## PRODUCT / PROCESS CHANGE NOTIFICATION

PCN-000791

Date: MAR-08-2022

Semtech's tier 2 supplier has changed their manufacturing process sequence to improve the flex's robustness. The color of the flex plating area has also been changed, but the thickness dimension remains unchanged.

- **S-parameter Test**

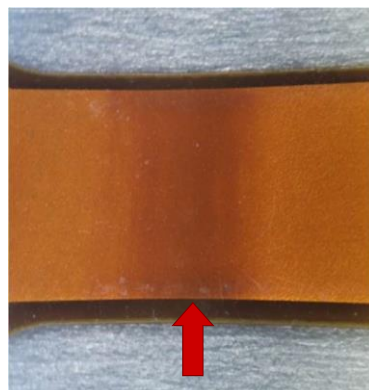
- The sample consisted of GN3357 ROSAs with old and new flex.
- The test specification was met.
  - When comparing new and old flex, there is no significant difference in bandwidth (BW) / RF measurement.
  - When comparing new and old flex, there is no significant difference in sensitivity performance (URS).

- **Bending Test**

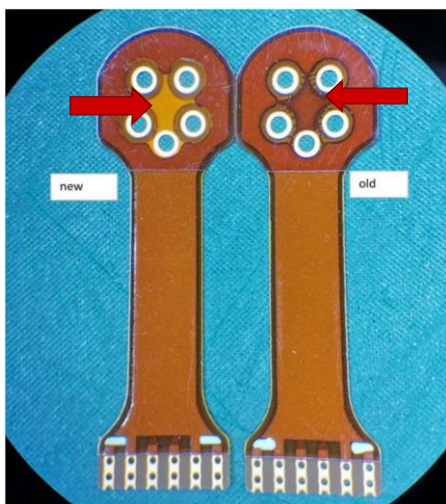
- Condition: Bending radius 0.4mm, 180 degrees, 25 times
- Samples: 11 units
- Result: The open/short test and visual inspection at the bending area both passed.

### Visual Inspection

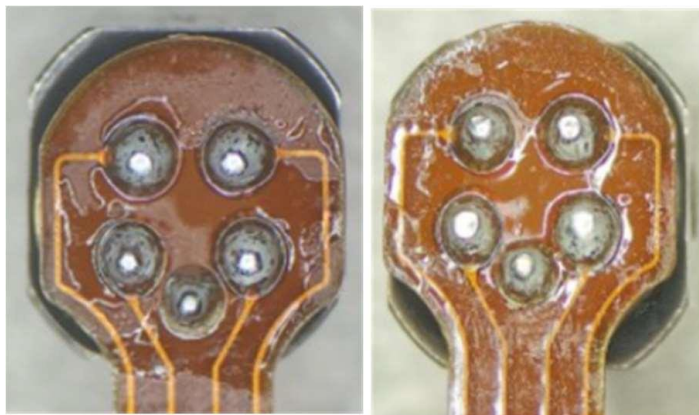
- A slight color difference can be seen in the center of the back side, left photo. There is no color difference on the front side, as shown in the right photo.
- Visual inspection passed Semtech criteria.

### Dimension Measurement

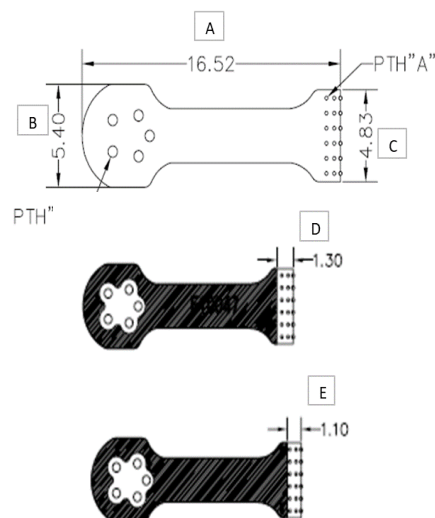
- Measuring the critical dimensions
- Result: Passed
